# DART SERVICE INSTRUCTION

TO AMEND INSTALLATION INSTRUCTIONS IIN-D412-775 REV. A  
AND INSTRUCTIONS FOR CONTINUED AIRWORTHINESS ICA-D412-775 REV. 0  
REF. TCCA STC SH08-53  
REF. FAA STC SR02692NY  
REF. EASA STC EASA.I.M.R.S.01529

A	NEW ISSUE		RF	11.04.29
REV.	DESCRIPTION		BY	DATE
DESIGN	RF	DART AEROSPACE LTD		
DRAWN	RF	HAWKESBURY, ONTARIO, CANADA		
CHECKED		DRAWING NO.	REV. A	
MFG. APPR.	N/A	DSI 9555	SHEET 1 OF 2	
APPROVED		TITLE	SCALE	
DE APPR.		FUEL PROTECTIVE TRIM CHG	NTS	
DATE	11.04.29		COPYRIGHT © 2011 BY DART AEROSPACE LTD	
THIS DOCUMENT IS PRIVATE AND CONFIDENTIAL AND IS SUPPLIED ON THE EXPRESS CONDITION THAT IT IS NOT TO BE USED FOR ANY PURPOSE OR COPIED OR COMMUNICATED TO ANY OTHER PERSON WITHOUT WRITTEN PERMISSION FROM DART AEROSPACE LTD.

**FIGURE 1. D3609-1 DOUBLER INSTALLATION**

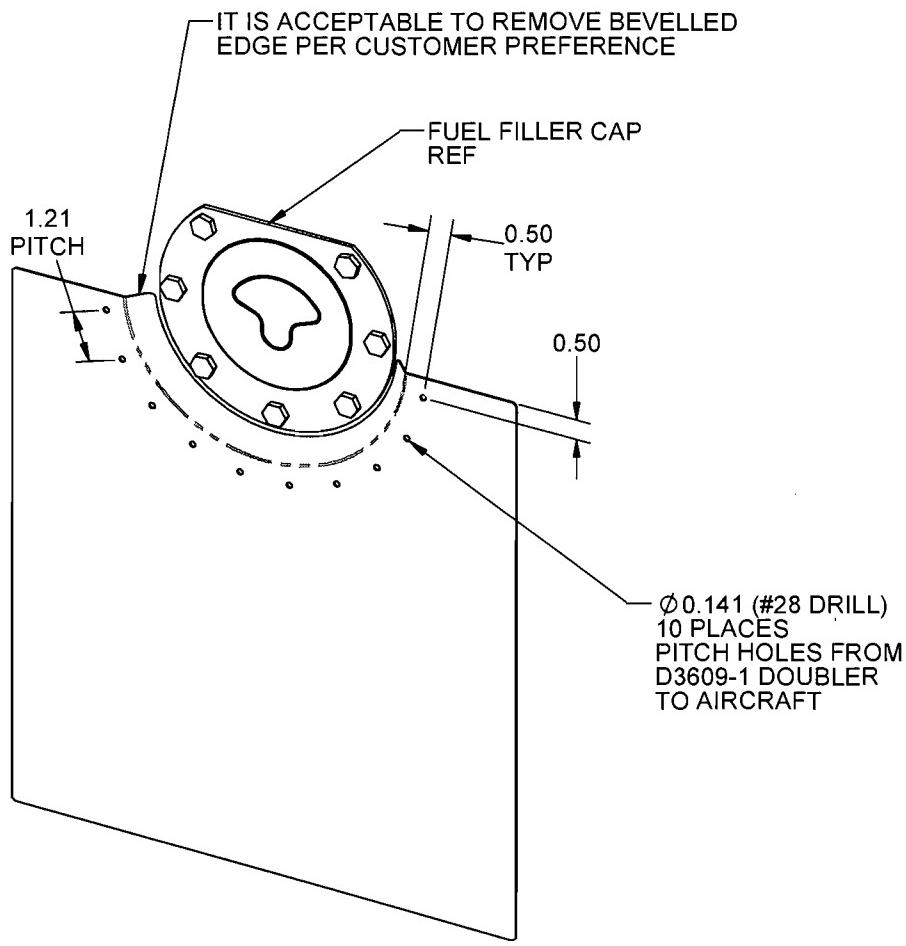
The D3609-1 doubler that is included in D412-775-015 kits at CHG 002 and later has been upgraded to include a bevelled edge on the top side that better protects the honeycomb core below the fuel cap from damage during refueling. The IIN/ICA documents are affected as follows:

3.3.3 Locate D3609-1 Doubler per Figure 5. Transfer drill #28 ( $\phi 0.141"$ ) existing rivet holes from the aircraft to the D3609-1 Doubler as shown in Figure 5. Pitch drill #28 ( $\phi 0.141"$ ) rivet holes 10 places from the D3609-1 Doubler to the aircraft skin as shown in Figure 1 of this DSI 9555.  
**NOTE:** It is acceptable to trim down the D3609-1 Doubler to fit and remove bevel per customer preference.

3.3.3 Locate D3609-1 Doubler per Figure 5. Transfer drill #28 ( $\phi 0.141"$ ) existing rivet holes from the aircraft to the D3609-1 Doubler as shown in Figure 5. Transfer drill #28 ( $\phi 0.141"$ ) rivet holes using pilot holes in the D3609-1 Doubler to the aircraft skin as shown in Figure 5.  
**NOTE:** It is acceptable to trim down the D3609-1 Doubler to fit.
